TULSA METROPOLITAN AREA PLANNING COMMISSION

For Meeting No. 2480

May 16, 2007 1:30 PM

<u>Shwiyat Estates – (9311) (PD 5) (CD 5)</u> 1720 South Memorial Drive

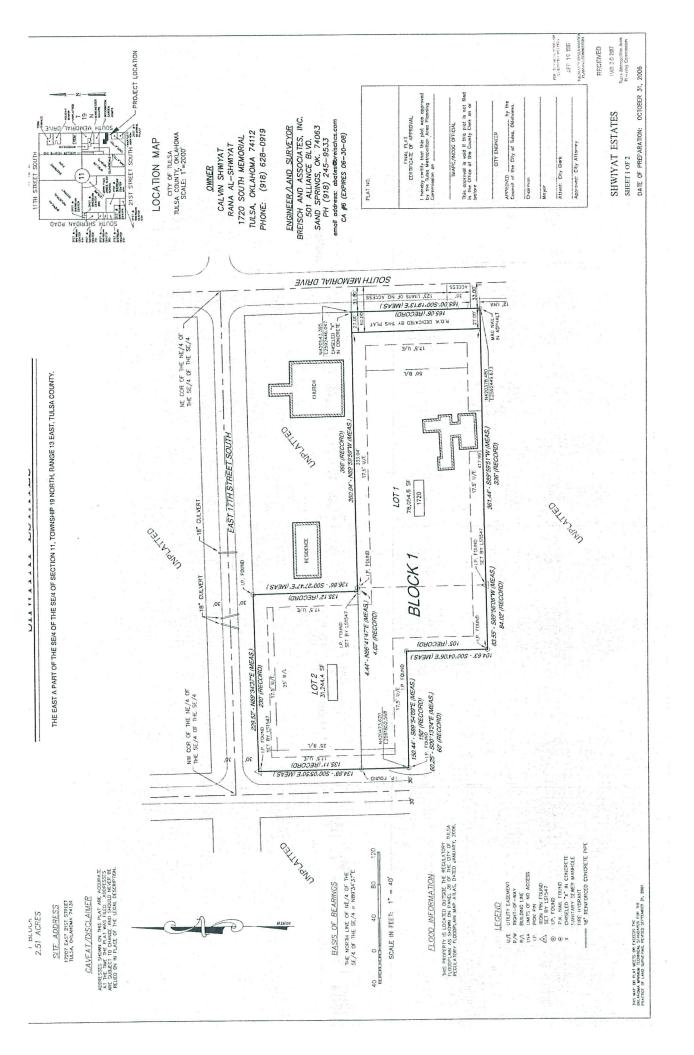
- **1. Zoning:** The property is zoned RD, RM-2, CS, RS-3. Sidewalks are required.
- 2. Streets: Provide recording references and dimensions for existing right-of-way dedications on South Memorial and on East 17th Street and the other north-south residential street. Dedicate a 25-foot intersection radius on the northwest corner of Lot 2.

- **3. Sewer:** Add a 15-foot easement, 7.5 feet each side of the lot line, between Lots 1 and 2, to allow for a future sanitary sewer mainline extension.

- **4. Water:** Existing waterlines on two sides of property (Memorial Drive and 79th East Avenue). Suggest putting a fire hydrant at the south property line on the west side of Memorial Drive for better fire protection.

- 5. Storm Drainage: Stormwater detention must be provided for the subdivision. The City of Tulsa policy is for all stormwater detention required for a development to be provided at the developmental stage of the subdivision. Show the location and Reserve Area for this facility on the face of the plat. Remove the language in Section II.F and replace it with the standard language for stormwater detention in a Reserve. The existing contour lines are not labeled with their respective elevations, therefore it is not possible to determine from this plan if off-site drainage flows onto this site. Many of the proposed spot elevation call-outs are not readable, due to the size of the lettering and the quality of the print. This site will not be allowed to increase the volume or velocity of drainage runoff flowing to the adjacent properties.

- 6. Utilities: Telephone, PSO, ONG, Cable: Release letters were received.
- 7. Other: Fire: Where a portion of the facility or building hereafter constructed or moved into or within the jurisdiction is more than 400 feet from a hydrant on a fire apparatus access road, as measured by an approved route around the exterior of the facility or building, on-site fire hydrants and mains shall be provided where required by the fire code official. Exceptions: For Group R-3 and Group U occupancies, the distance requirement shall be 600 feet. For buildings equipped throughout with an approved automatic sprinkler system installed in accordance with Section 903.3.1.1 or 903.3.1.2, the distance requirement shall be 600 feet. Delete the previous north/south lot split line in Lot 1 and also delete culverts shown of the face of plat. Property description under plat title needs correction. Site address on face of plat is incorrect. The 17.5-foot utility easement along south property boundary needs

additional dimensioning where the building would encroach. Topographic information, such as existing buildings and culverts, should not appear on the face of a Final plat. Recommend approval as a Preliminary Plat. Please provide standard language in the dedication to declare both the legal ownership and the subdivision name. Legal description needs to include "also being described as..." bearings and distances that match face of plat and tying to section corner.

GIS: Please show distance and bearing of dividing line between Lots 1 and 2. Include metes and bounds description with boundary distance for the boundary of the plat.

Staff recommends **APPROVAL** of a Preliminary Subdivision plat and not the Minor Subdivision Plat submitted due to the numerous requirements to be met for public works staff, subject to the TAC comments and the special and standard conditions below.

<u>FedEx Ground Westmoreland</u> – (0420) (PD 16) (CD 6) Northwest corner of East Apache Street and 129th East Avenue

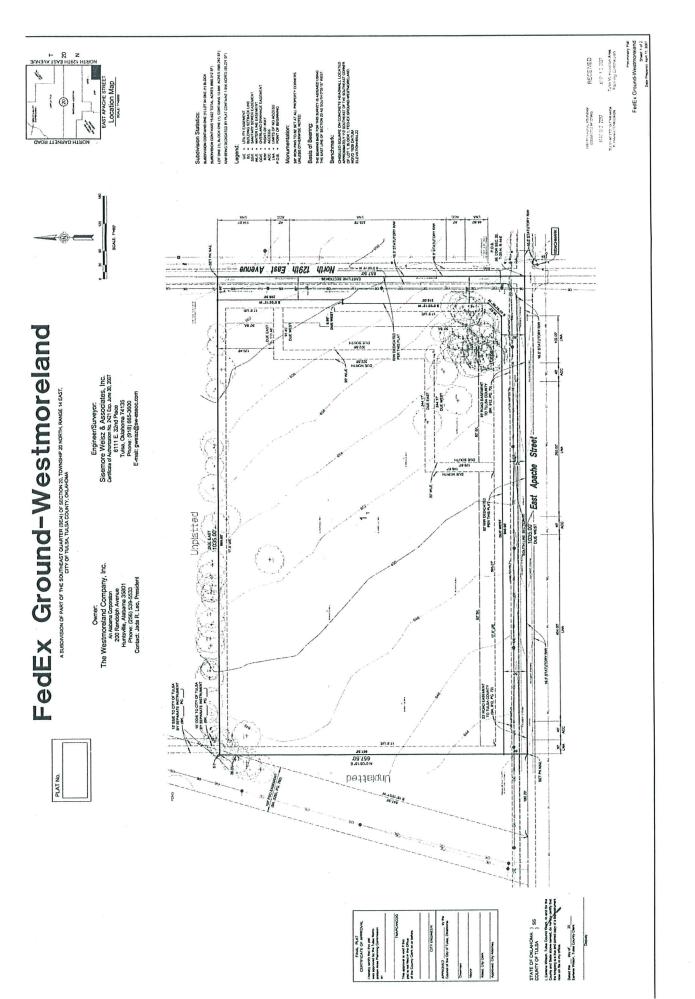
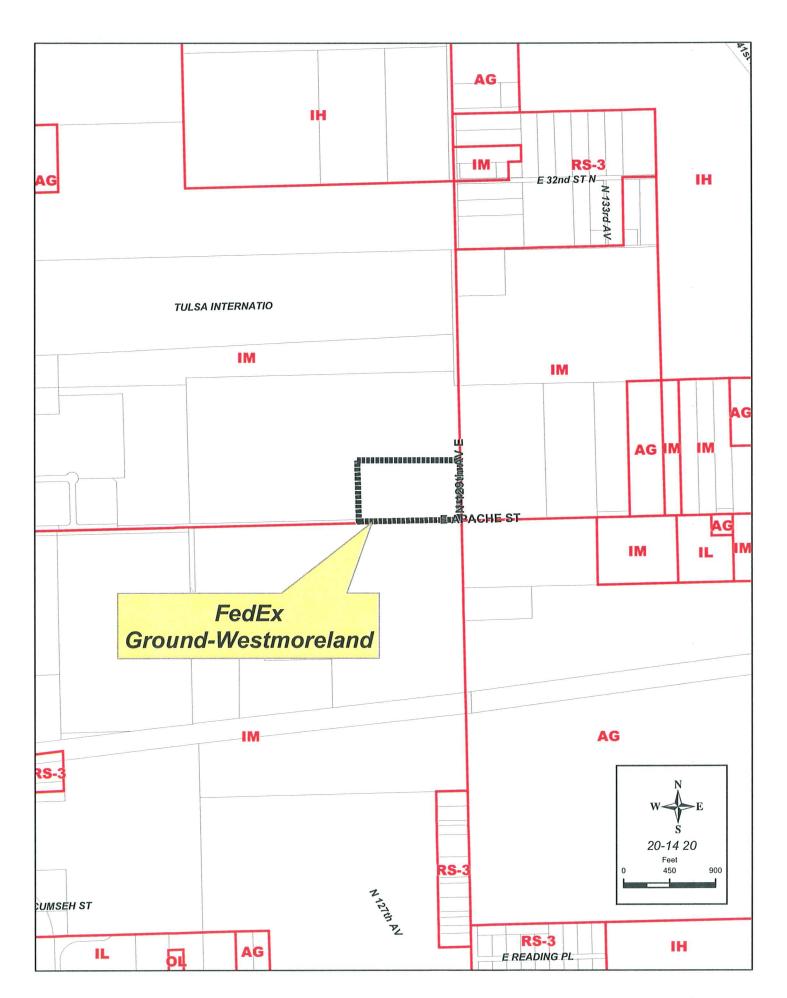
- 1. **Zoning:** The property is zoned IM.
- 2. Streets: Proposed right-of-way dedications meet Major Street and Highway Plan requirements. Sidewalks are shown as commented on at predevelopment meeting. Recommend deleting accesses nearest the intersection on both Apache and 129th East Avenue. Include Limits of No Access along the diagonal corner of the intersection.

- **3. Sewer:** An SSID project is underway to extend sanitary sewer service to this development.
- **4. Water:** Water main extension will be required.

- **5. Storm Drainage:** The developer has the option of paying fees in-lieu-of-detention. Overland drainage needs to be put in an easement.
- 6. Utilities: Telephone, PSO, ONG, Cable: No comment.

- 7. Other: Fire: No comment. GIS: The point of beginning on the face of plat does not match that in the legal description. The right-of-way area shown to be "dedicated by this plat" is not included in the legal description; the plat and/or legal description need correction. The legal description does not match face of plat.

Staff recommends **APPROVAL** of the Preliminary Subdivision plat subject to the TAC comments and the special and standard conditions below.
